PROJECT: Hualapai ? Isaac Newton Single Family Residential

SUBMITAL: 1st

CITY OF LAS VEGAS		DATE:
INTER-OFFICE MEMORANDUM		August 10, 2020
TO: Land Development Services Department of Building & Safety		FROM: Albert Sung, P.E. Flood Control Project Engineer Department of Public Works
SUBJECT:	Drainage Study for:	COPIES TO:
	Hualapai & Isaac Newton Single Family Residential	VTN Nevada
Cross Streets:	NEQ of Hualapai Way & Isaac Newton Way	AMH Development West GC, LLC
File Number:	F:\Depot\DSMemos\DS5297A.doc	Bart Anderson, P.E., DevCo
Parcel Number:	138-07-401-001	
Zoning Action:	GPA-77926; MOD-77927; SDR-77928; TMP-77930 & VAR-77931	
FEMA Flood Zone	YES NO X	
Proposed Storm Drain	YES NO X

FIGURE 6: EXISTING CONDITION DRAINAGE MAP
HUALAPAI AND ISAAC NEWTON

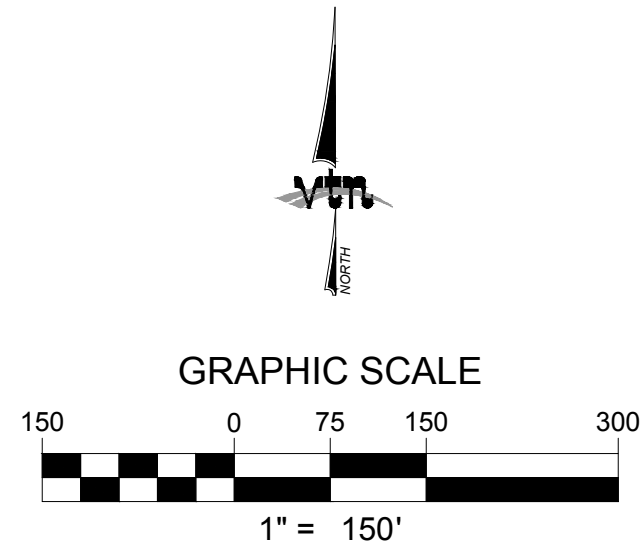
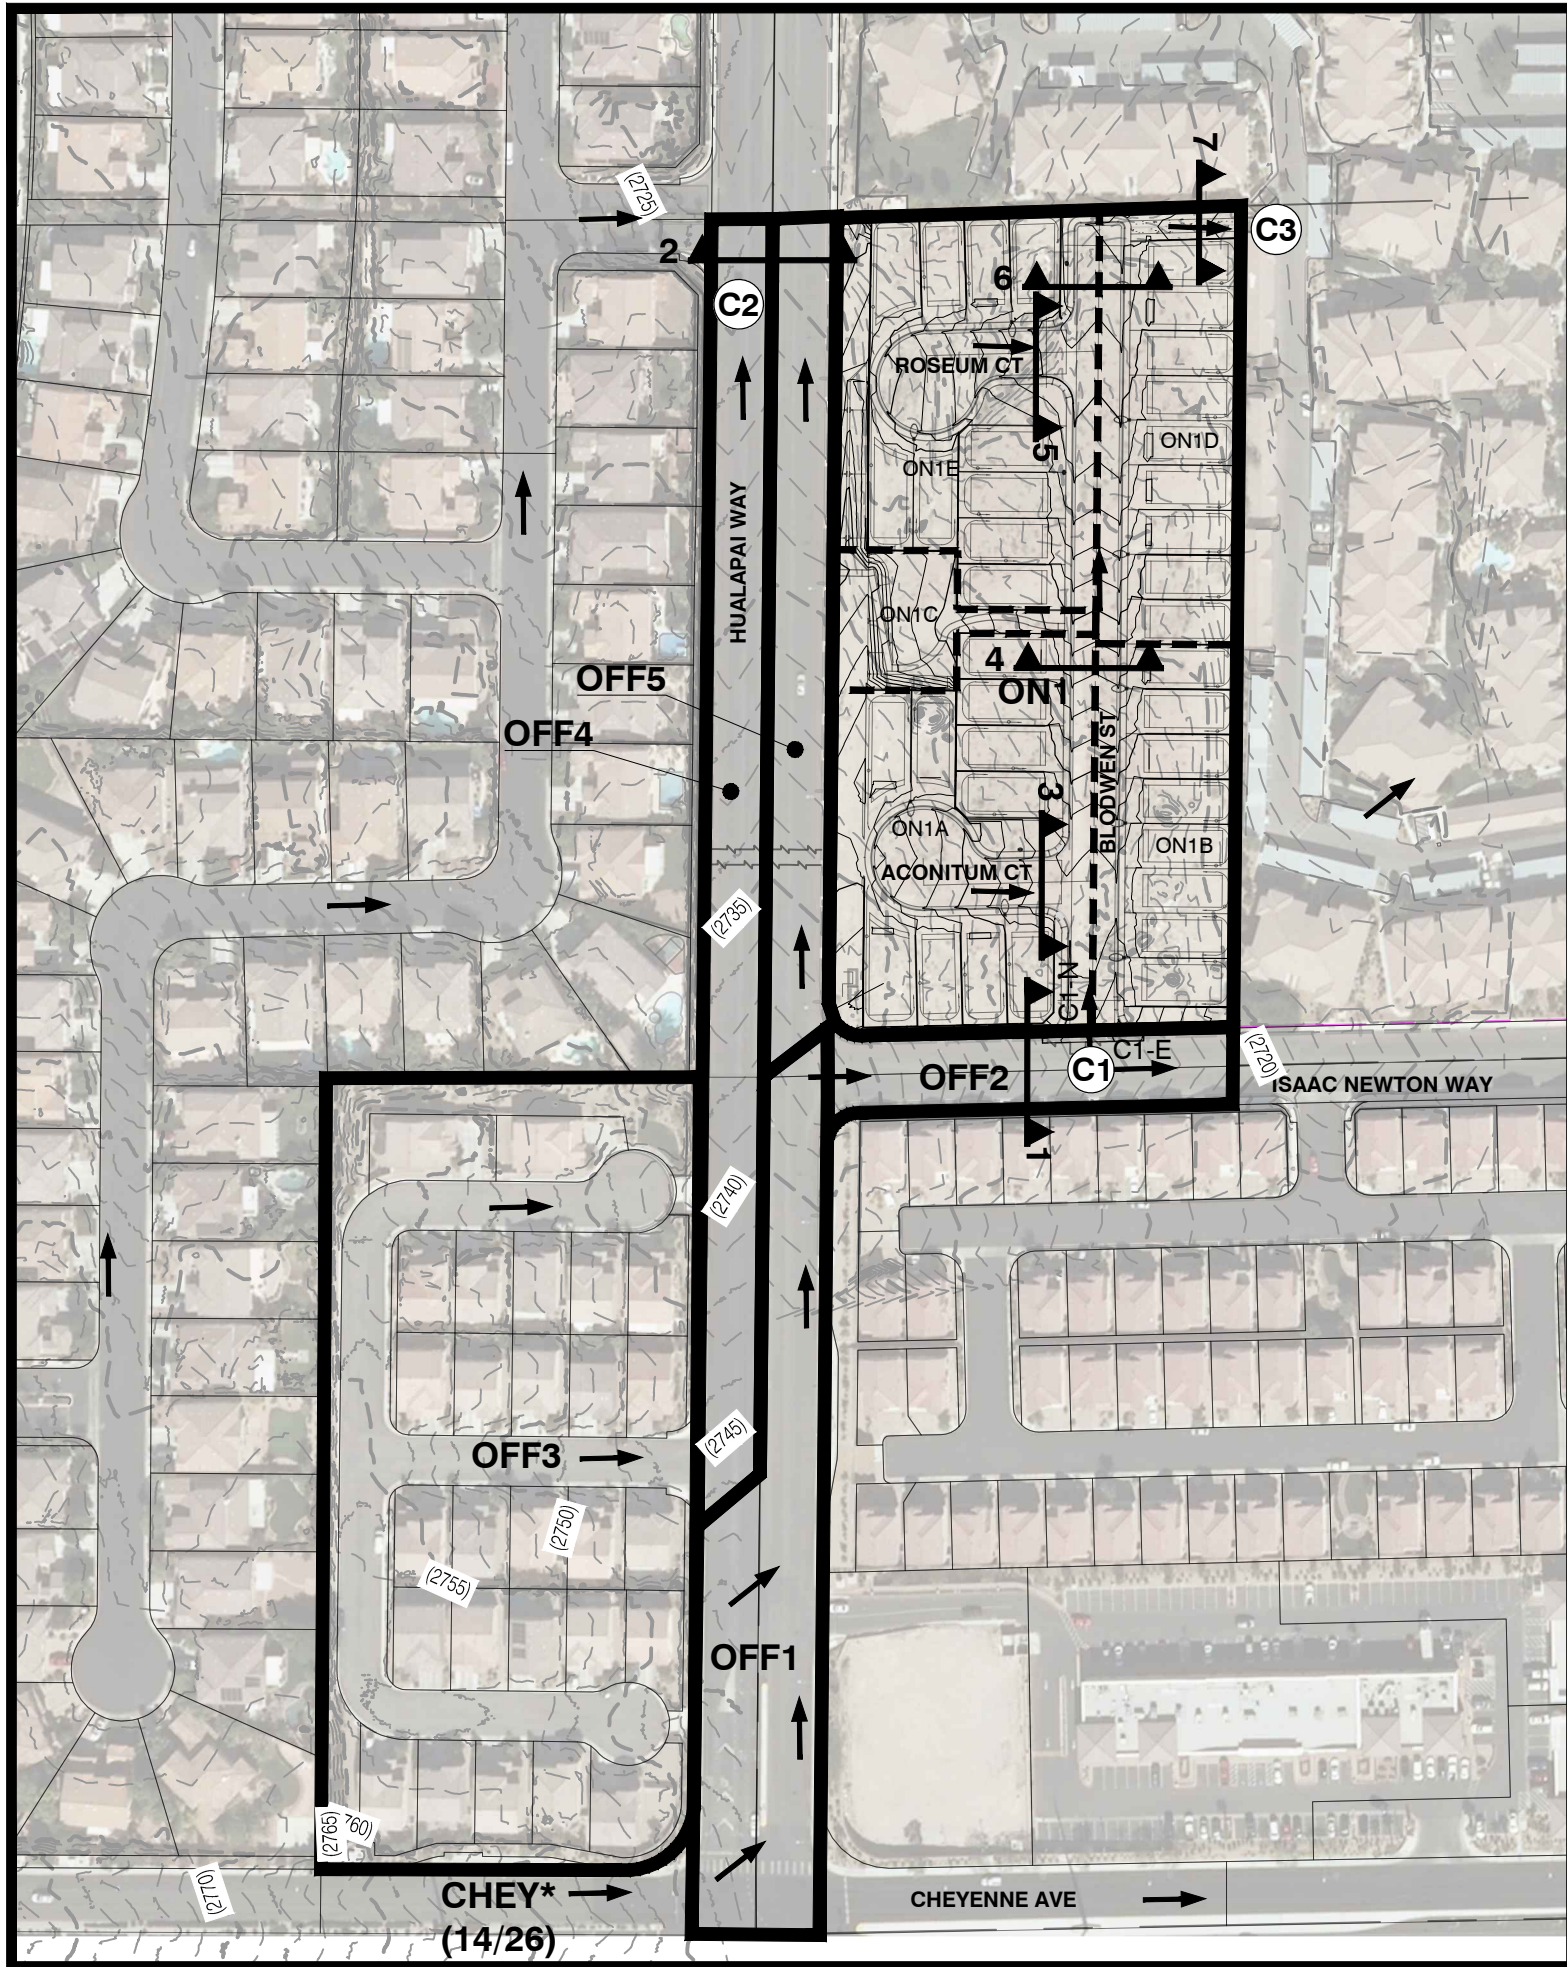
7. **Figure 6 (Existing Condition Drainage Map):** Provide a concentration point at the northeast corner of the subject site on the plan and the *HEC-1 Summary Table* in the next submittal.

FIGURE 503

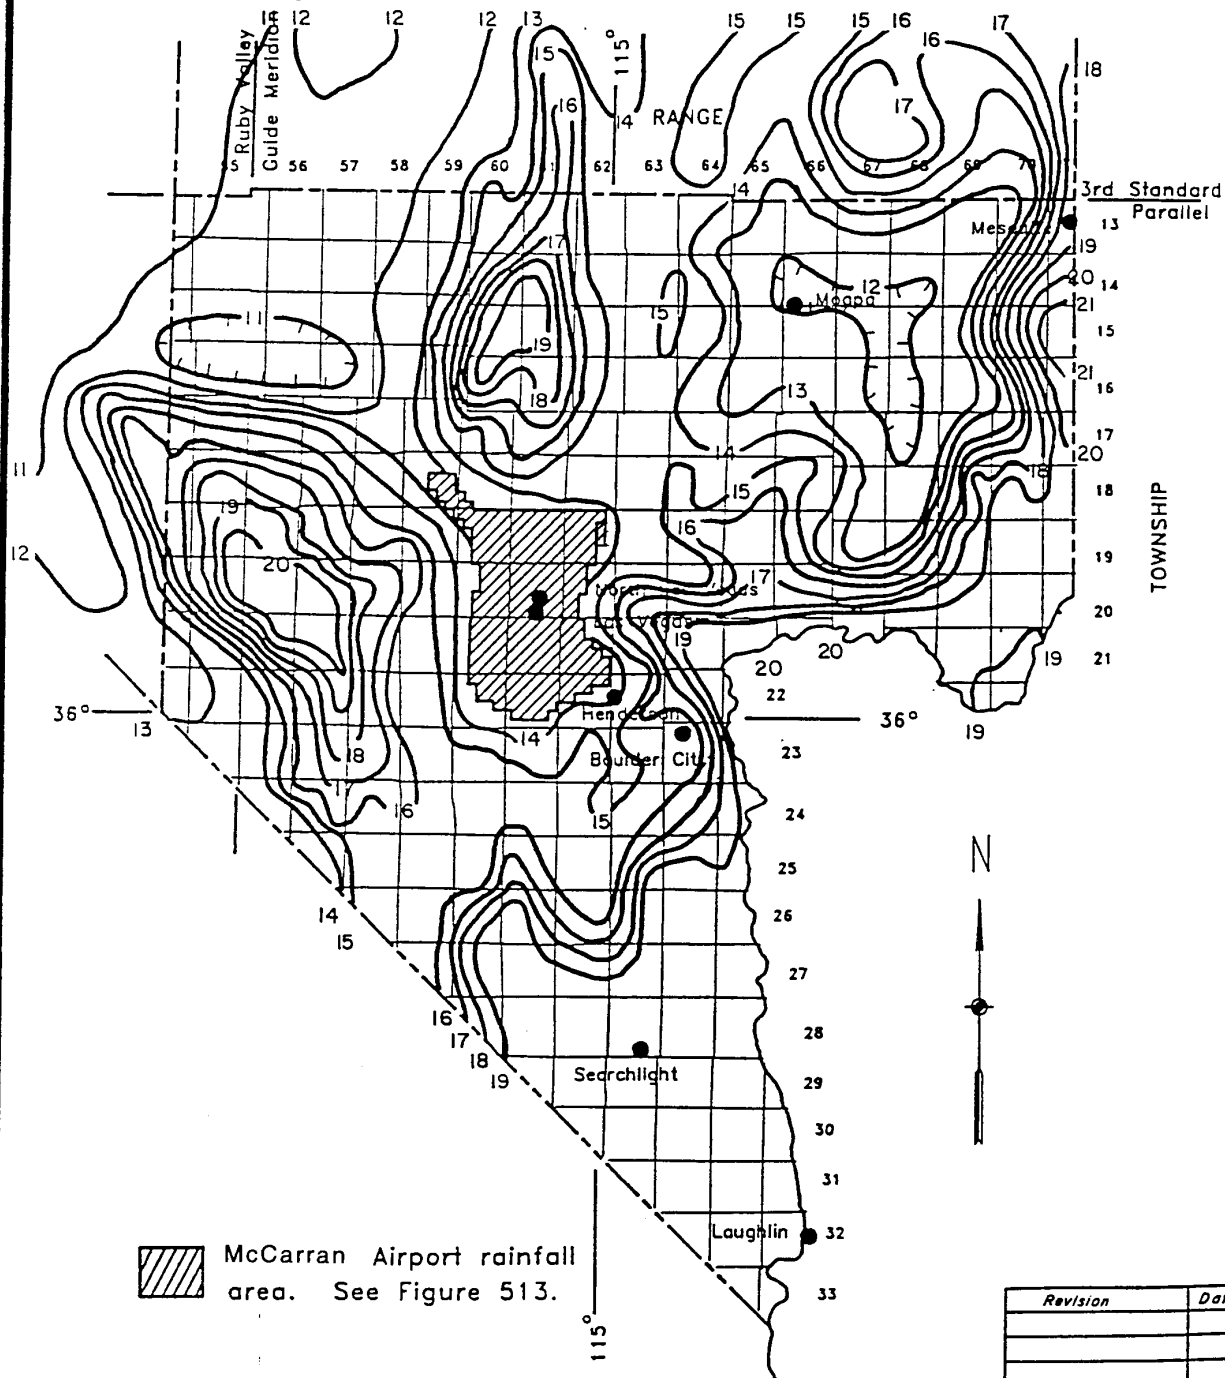
- Provide rainfall depth calculations for outside of the McCarran rainfall area. Show the site location on Figures 503 and 506 from the HCDDM.
- In *Standard Form 1*, correct the "Range" information from R50E to R60E.

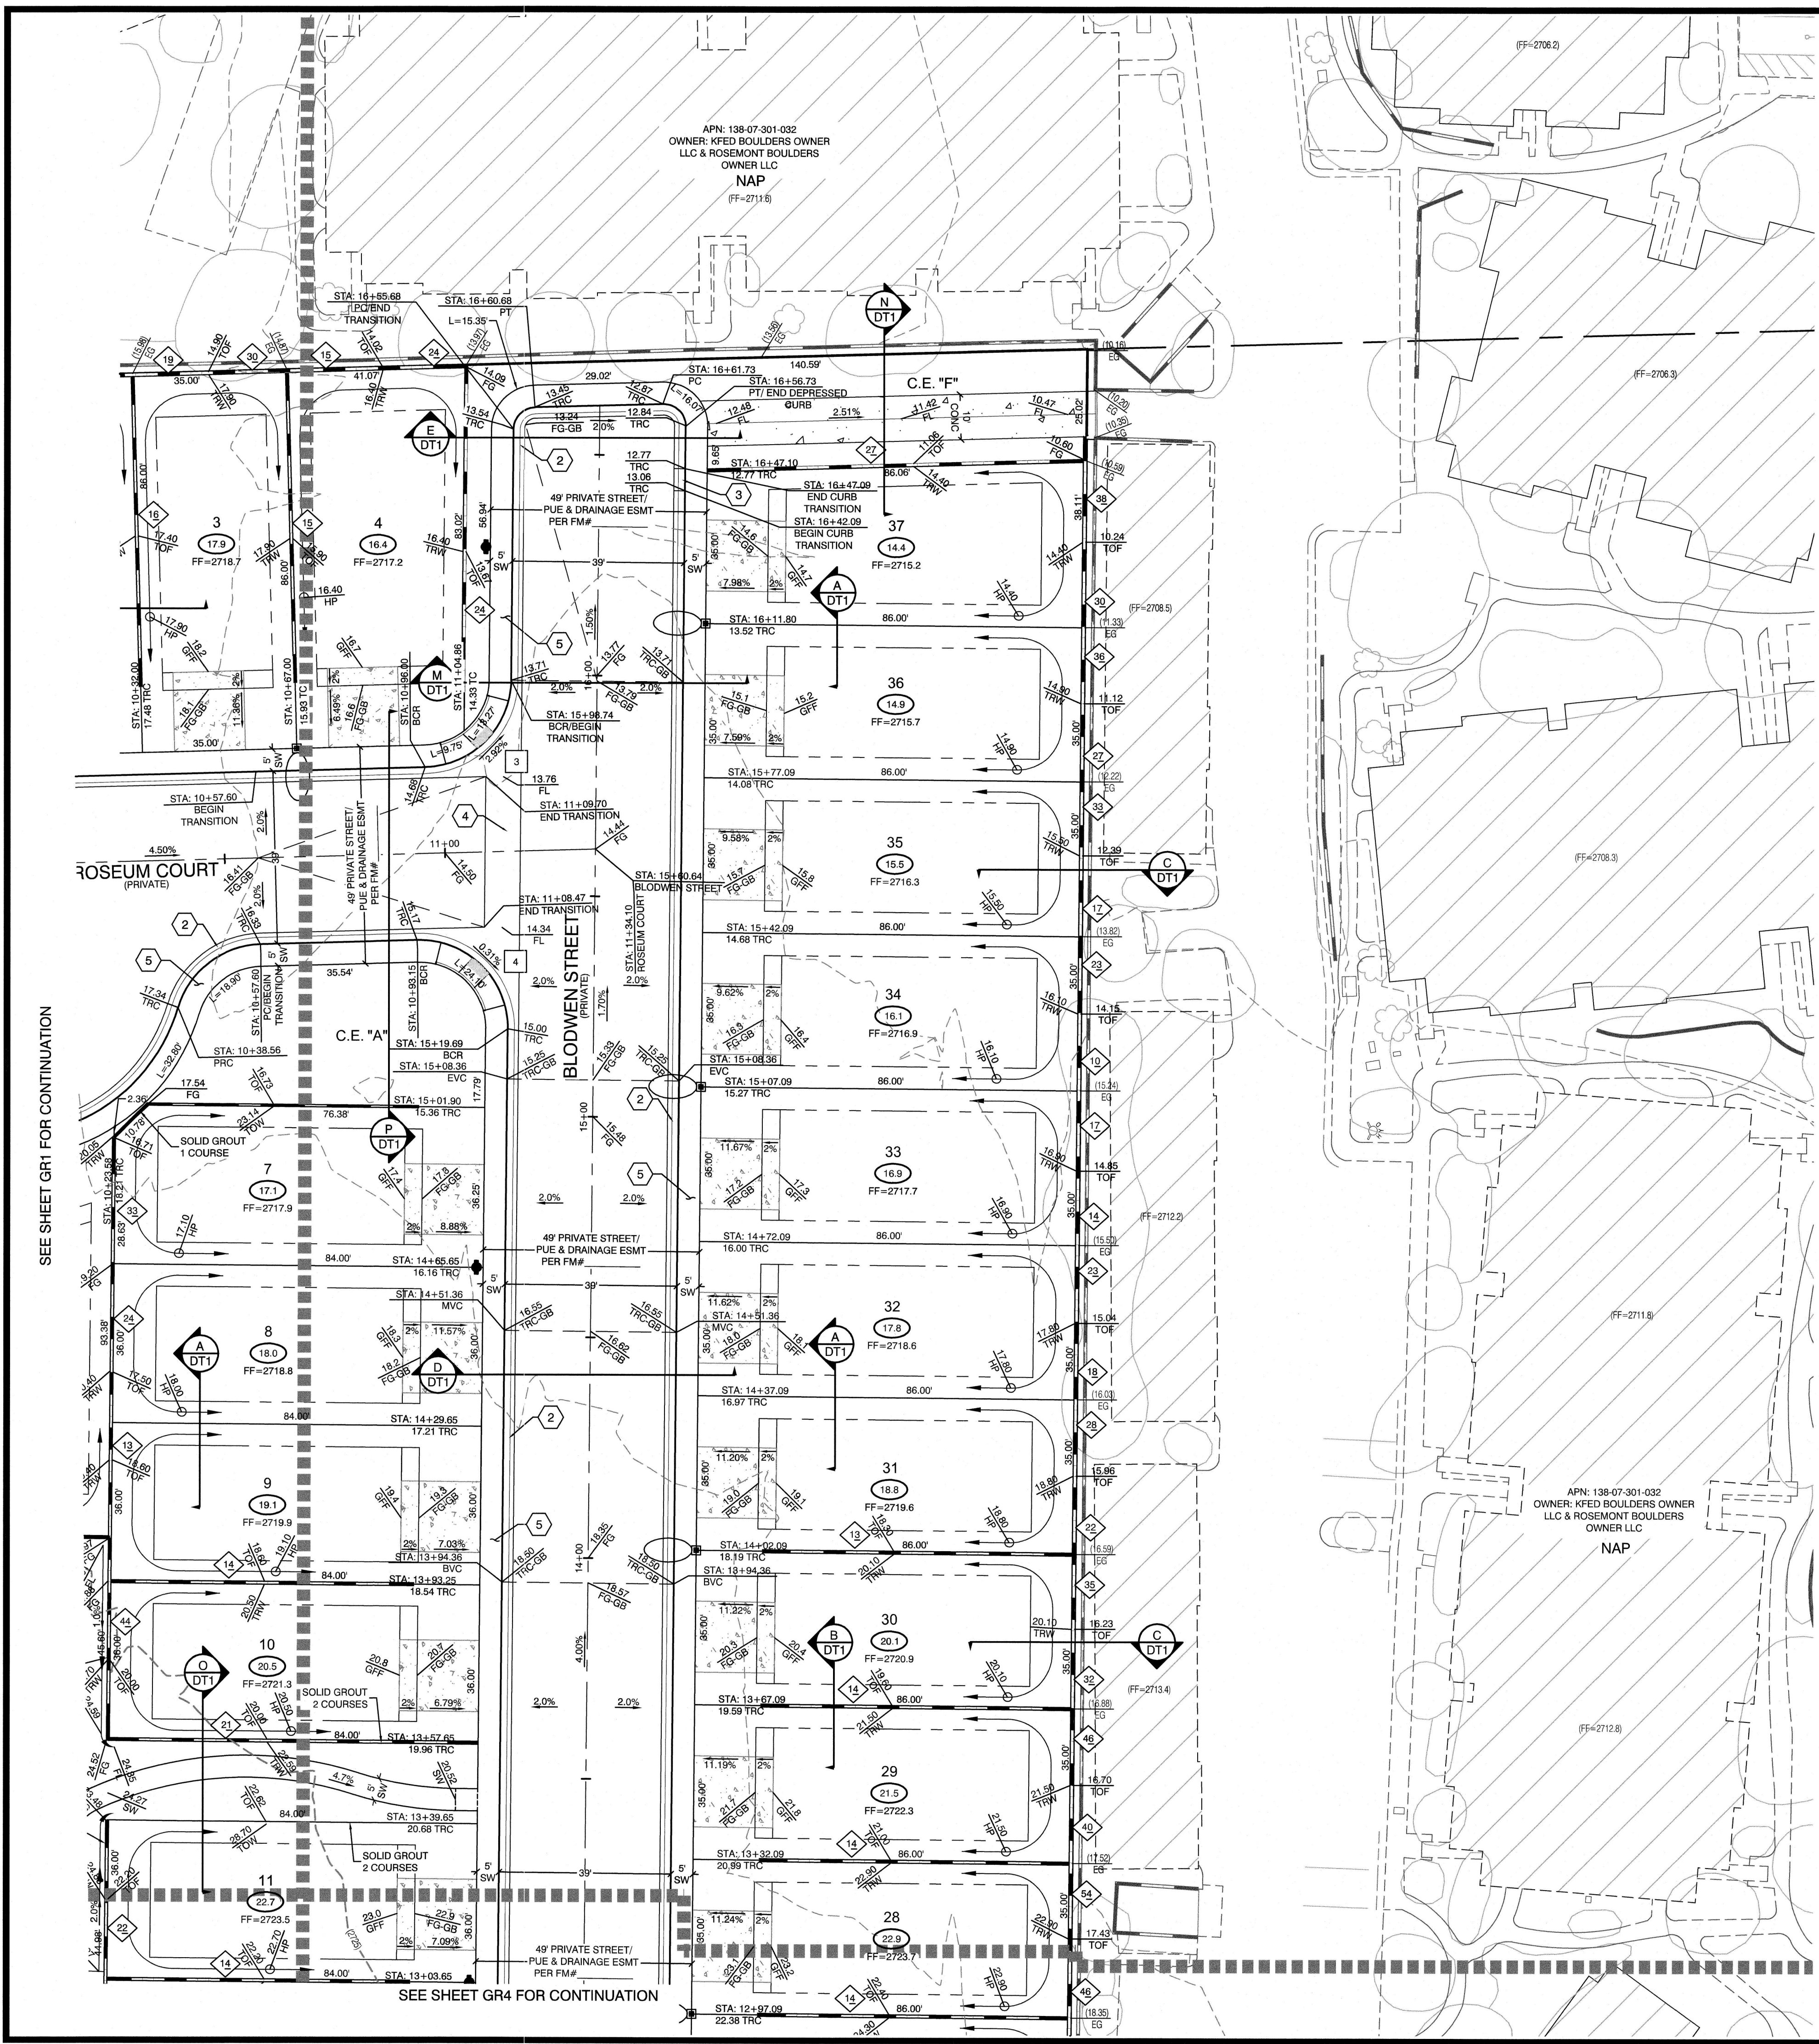
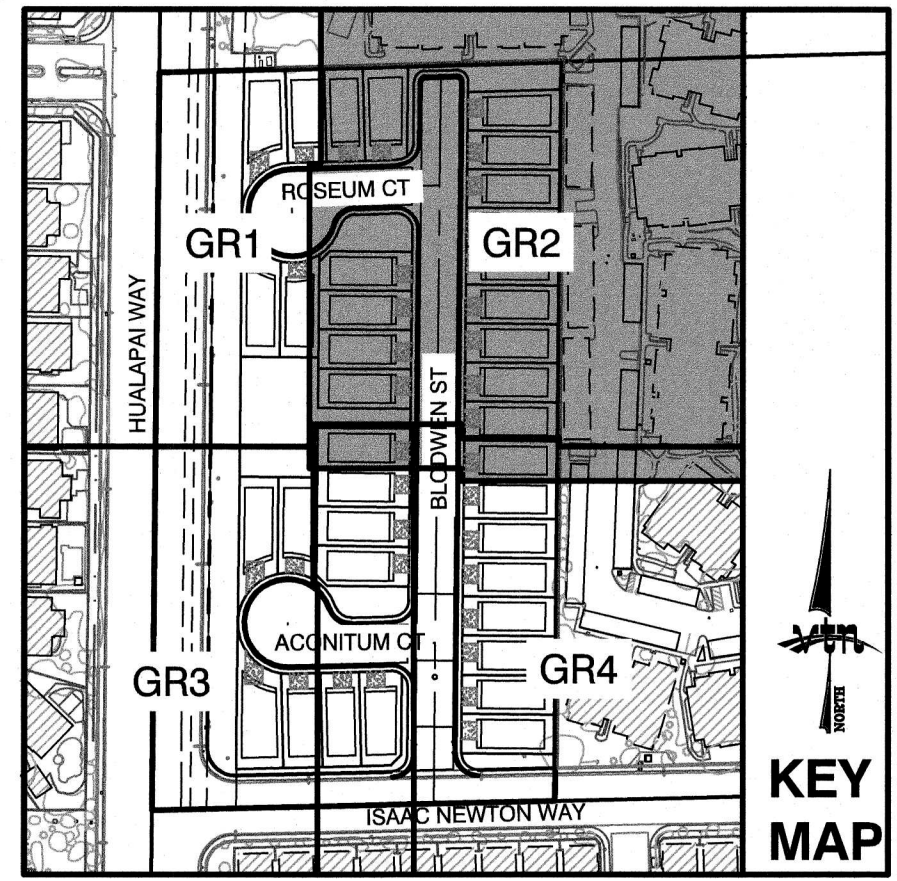
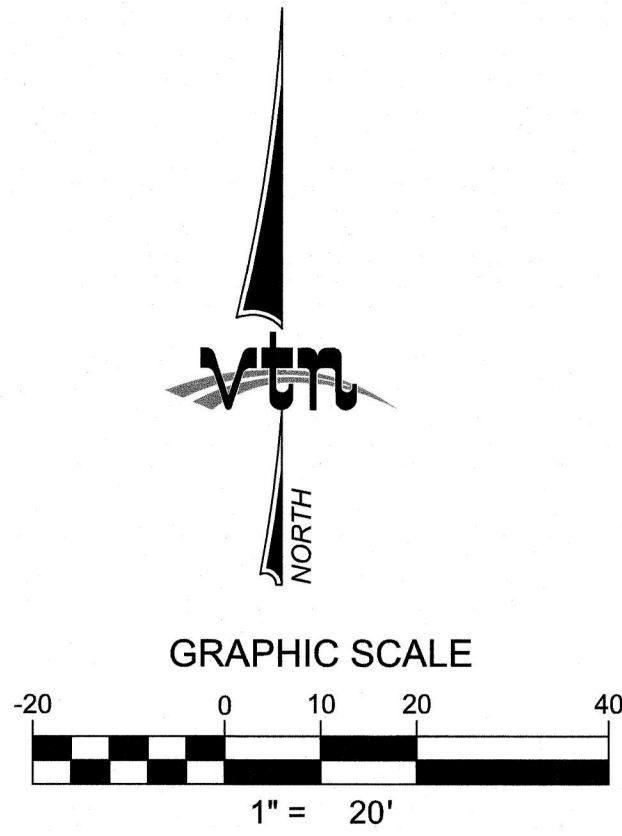
8. **Sheet GR1:** Show and label the slope in the bulb of *Roseum Court*. Note that the minimum slope in the bulb is 1%.
9. **Sheet GR2:** CE “F” must also be dedicated as a “Public Drainage Easement to be Privately Maintained by the HOA”.
